SAFETY RECALL NOTICE

QUICK-RELEASE MECHANISMS

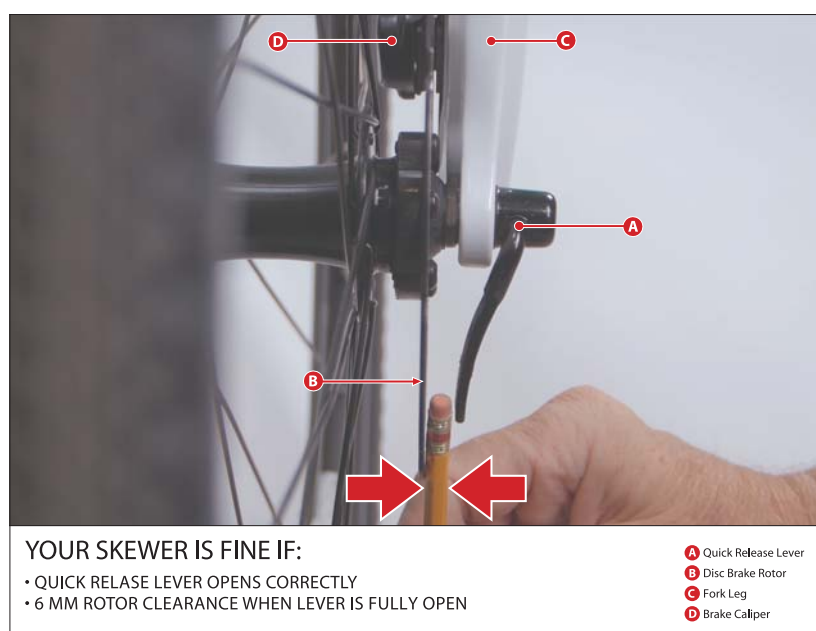
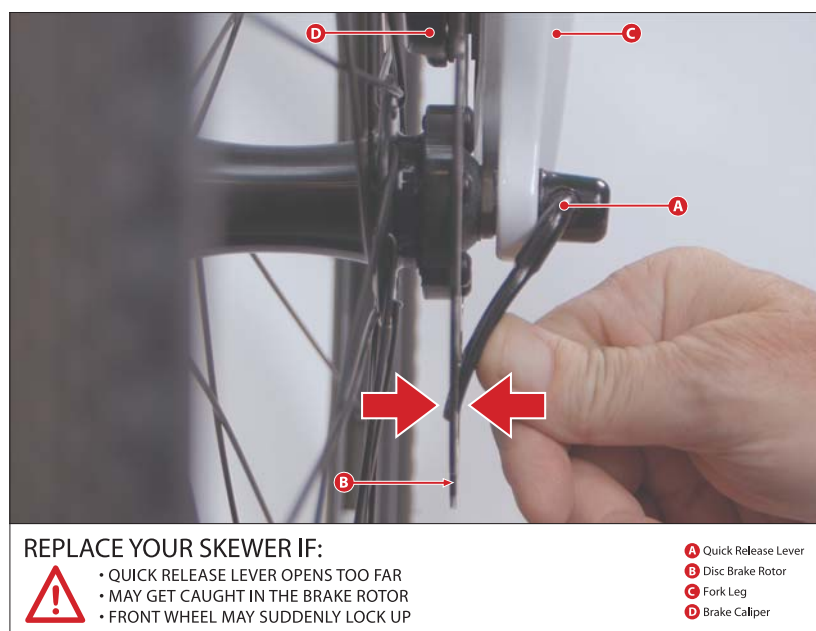
Front-wheel quick-release cam levers that are improperly adjusted or left open during riding and do not meet the #2 Pencil Test below may potentially interfere with the front disc brake rotor, which could result in the rider losing control and sustaining serious personal injuries.

This is a Safety Recall Notice regarding a group of bicycle brands listed below. Only bicycles equipped with front-wheel quick-releases and disc brakes are potentially affected. If the distance between the leading edge of the cam lever in its most open position and the disc rotor is less than 6 millimeters, which is the equivalent of the width of a standard #2 pencil (the “#2 Pencil Test”), your quick-release mechanism needs to be replaced. Please visit www.quickreleaserecall.com for a video demonstration of the #2 Pencil Test.

Stop riding the affected bicycle immediately and bring it to an authorized retailer of your bicycle’s brand, which will replace the affected quick-release free of charge. For any inquiries, go to www.quickreleaserecall.com, click on the brand of your bicycle, and proceed from there.
